Model: PRIPORT Platinum/Platinum P/Platinum2		Date: 22-Nov-07	No: M-C267-010a
Modified Article: New model Platinum2 information		Prepared by: K. Yamamoto	
From: Priport Service Planning Section			
Classification: ☐ Parts catalog correction ☐ Vendor change ☐ To meet standards ☐ To facilitate assembly ☐ To improve reliability () ☐ Part standardization ☒ Other (New machine information)			
Model Name: Platinum: Ricoh DX3340/DX3440C/DX3240, Gestetner CP6146/DX3440/CP6300C/DX3240, Savin 3180DNP, Lanier LDD120, RexRotary DX3440/DX3240, nashuatec DX3440/DX3240, Standard SD360 Platinum P (China only) Ricoh DX3440CP, Gestetner CP6300P Platinum 2 Ricoh DX3442/DX3442C/DX3242, Gestetner DX3442/CP6301C/DX3242, Rotary DX3442/DX3242, nashuatec DX3442/DX3242

This MB lists the parts unique to the Platinum2 (C271)

2. OPERATION PANEL

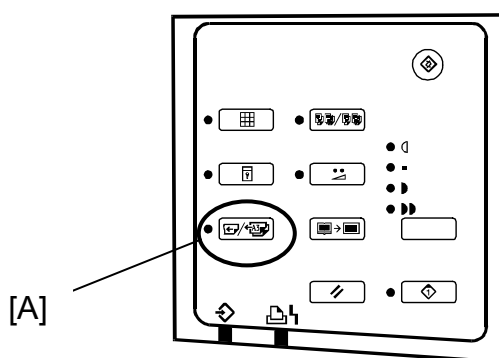
The [A] is changed

Sec	Page	Index	Parts No.	Description	Q'ty	MB No.
2	11	*	C2711450	Operation: Panel: EXP: Ass'y	1	-
2	11	2	C2711485	Sheet: Operation: Sub: Left: Chinese	1	-
2	11	6	C2711474	Key top: Memory	1	-

6. PAPER TABLE SECTION

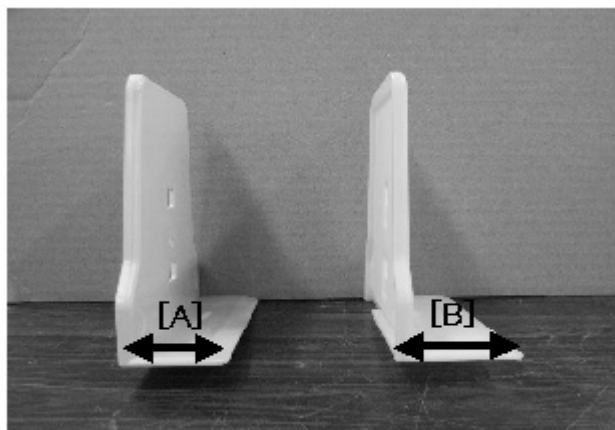
The length of side fence [B] (40.5mm) for Platinum2 is longer than [A] (32m) for PT.

Sec	Page	Index	Parts No.	Description	Q'ty	MB No.
3	19	18	C2672980	Side Fence: Paper Feed Tray	2	-
3	19	21	C2672710	Paper Feed Tray: CHN: Ass'y	1	-
